ARAMCO RESEARCH CENTER JSP22-19

Consideration at the request of Aramco Americas, for Preliminary Site Plan approval. The subject property is located in Section 4, east of Hudson Drive and north of West Road, and is zoned I-1, Light Industrial. The applicant is proposing to install outdoor storage tanks with liquid hydrogen and natural gas in the existing parking area on the south side of the building.

PLANNING REVIEW

Review Date: May 24, 2022
Review Type: Preliminary Site Plan
Project Name: **JSP 22-19: ARAMCO TANK ENCLOSURE**
Location: 22-04-378-034; 46535 Peary Ct
Plan Date: May 3, 2022
Prepared by: Lindsay Bell, AICP, Senior Planner
E-mail: lbell@cityofnovi.org; **Phone:** (248) 347-0484

Sheet Number: **L-1.0** Rev. No.

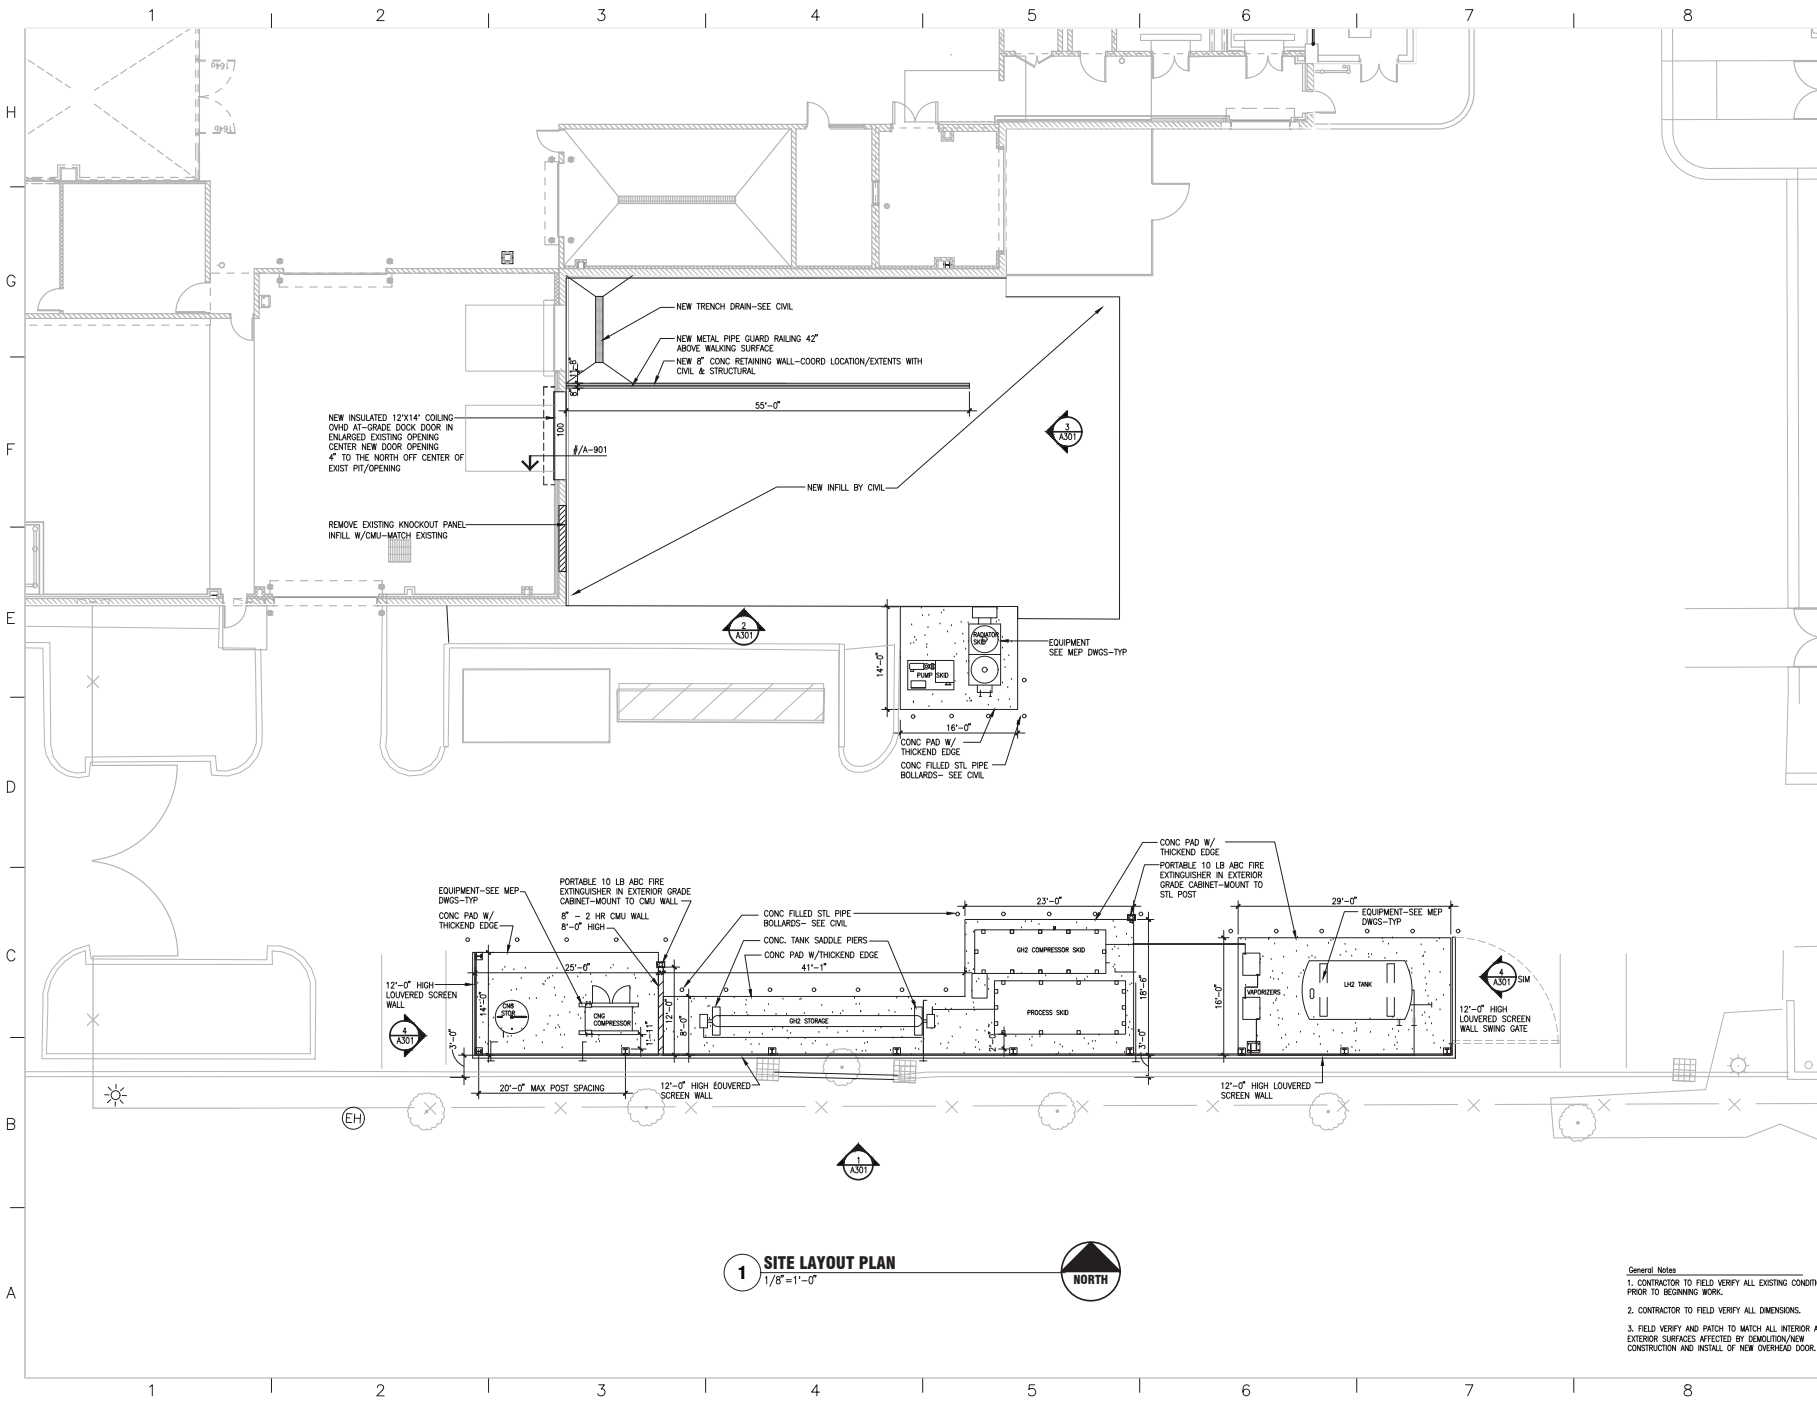
1. Earlier plans indicated that a storm sewer may be passing underneath the landscape island west of the proposed equipment.
2. **Please move the eastern tree south of the existing hydrant to ten feet away from the hydrant and the catch basin (it will probably need to move to the southeast a bit).**
3. **Please move the western NS3 north a bit to provide 5 feet from the underground utility line.**

1. The irrigation note just states the city requirements for irrigation but does not say specifically how the plants will get water. Please add this information.
2. If the existing system will be modified to provide water for the proposed plantings, please add a note to this effect on Sheet L-1.
3. If a new system is proposed for the new landscaping and/or any other landscaping, please provide that plan with revised Final Site Plans.

2. Please move the eastern tree south of the existing hydrant to ten feet away from the hydrant and the catch basin (it will probably need to move to the southeast a bit).
Design Team Response: Noted
3. Please move the western NS3 north a bit to provide 5 feet from the underground utility line.
Design Team Response: Noted

Sheet Number M-100	Rev. No.
------------------------------	----------

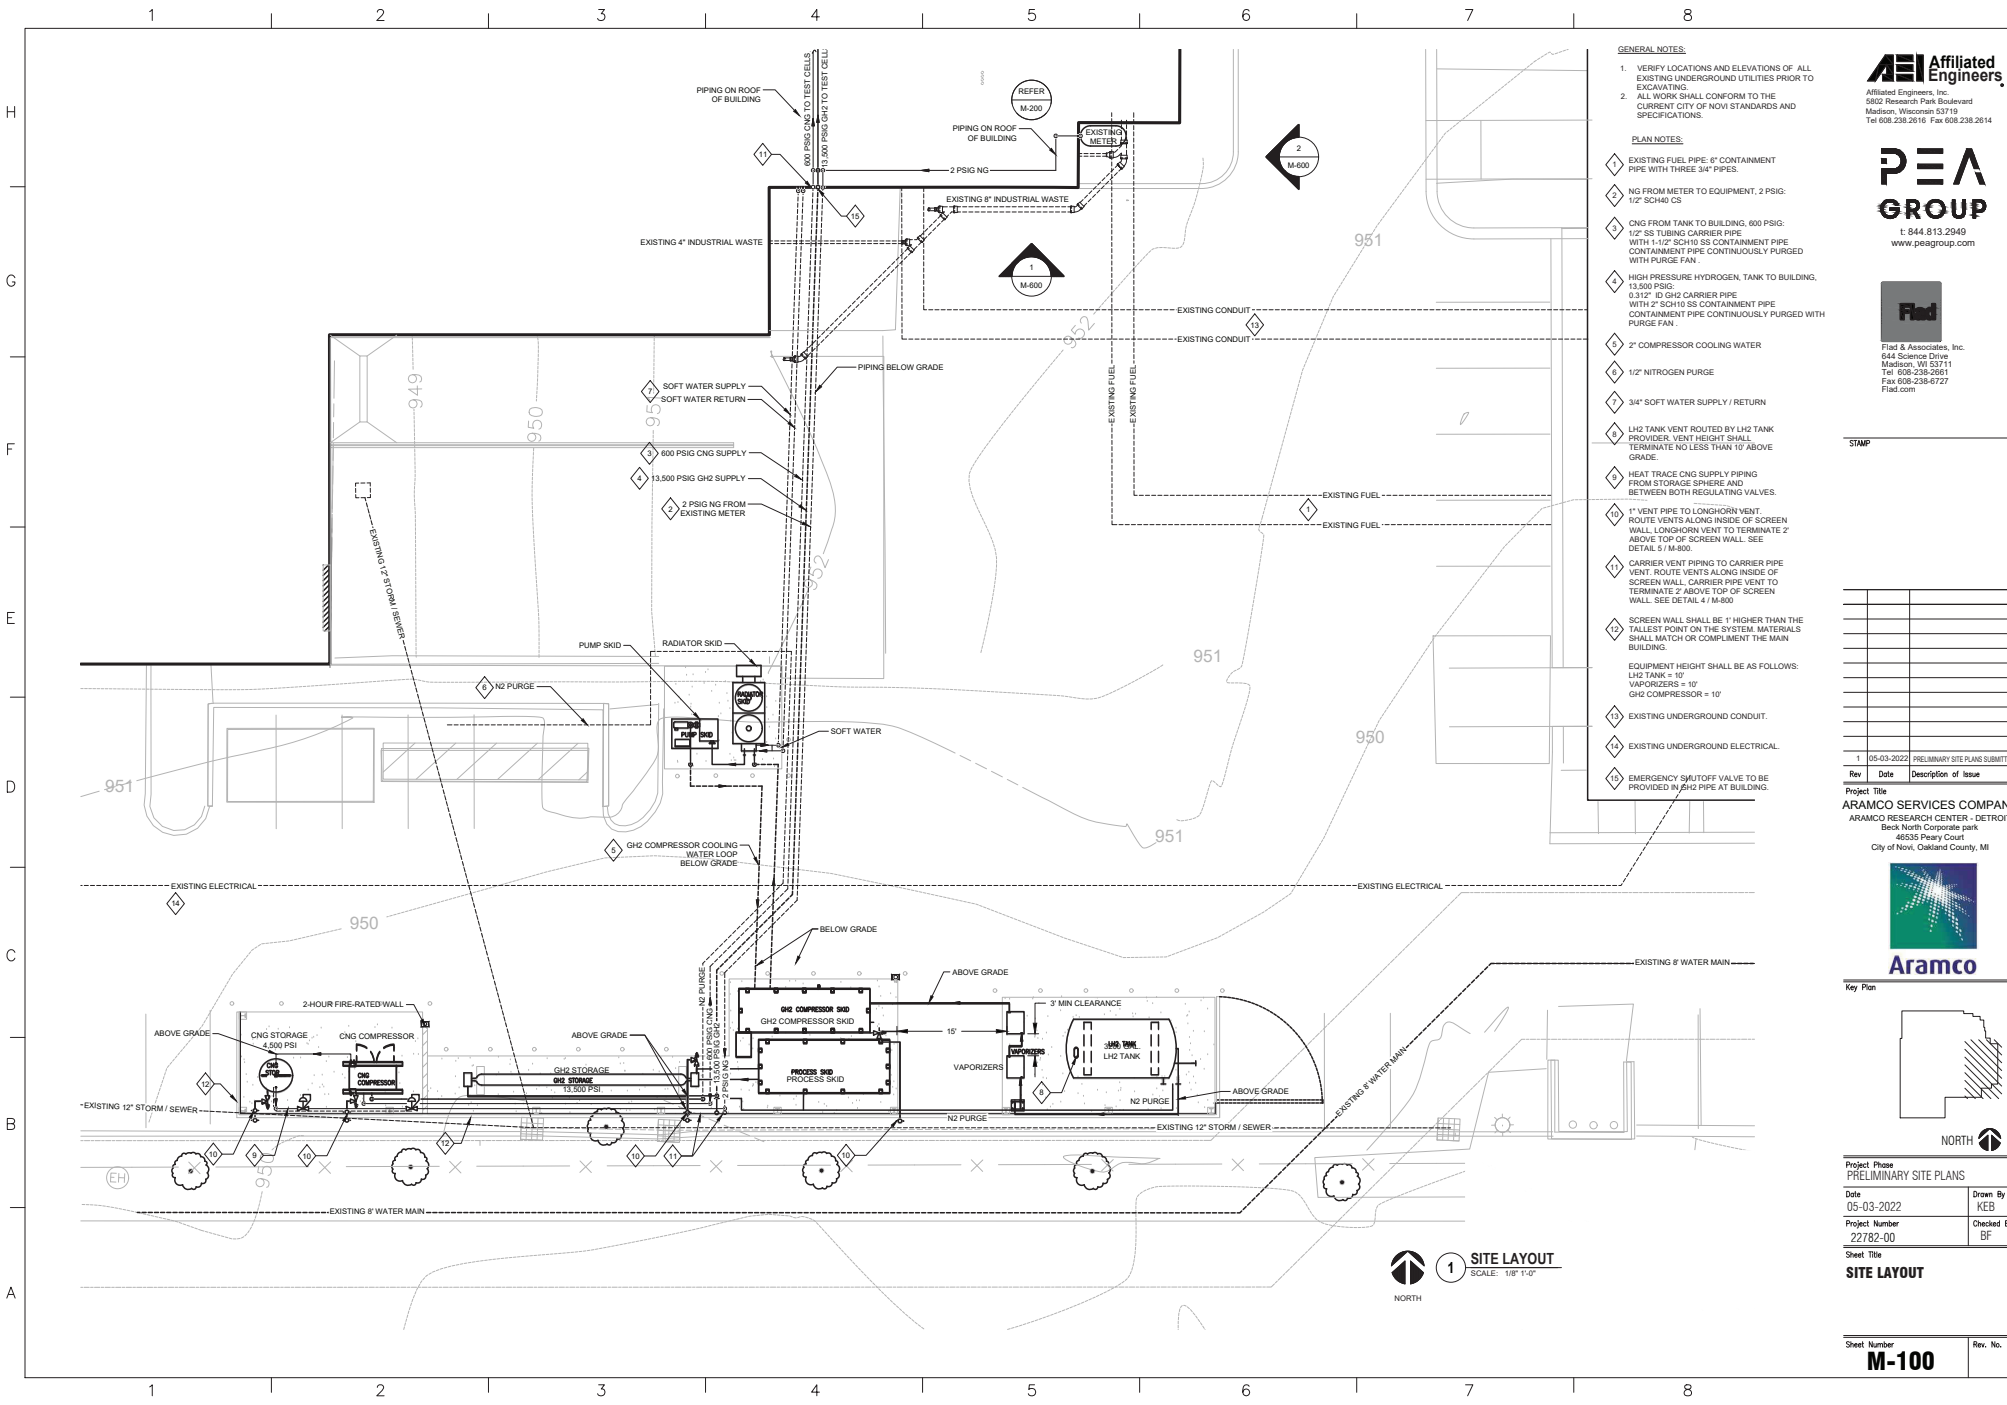
5. Screening: A vent pipe is proposed to extend above the screening wall, which is required by NFPA.
Design Team Response: Correct, agreed.
8. Performance Standards: The applicant shall confirm that the NFPA code does not allow the proposed tanks to be completely enclosed in a building, and that the proposed screening walls meet the requirements of the Building and NFPA.
Design Team Response: Per NFPA 2 (2011), Table 8.3.2.2.1.4, liquid hydrogen systems storing more than 600 gallons shall be installed outdoors. Per NFPA 2 (2011), section 8.3.2.4.4.5(D), stationary liquid hydrogen containers shall not be installed in an enclosed court, which is defined as a court "bounded on all sides by the exterior walls of a building or by the exterior walls and lot lines on which walls are permitted." Installing screen walls on three sides of the liquid hydrogen equipment meets the requirements of NFPA 2.

Design Team Response: We are in compliance with NFPA 2 and NFPA 55.
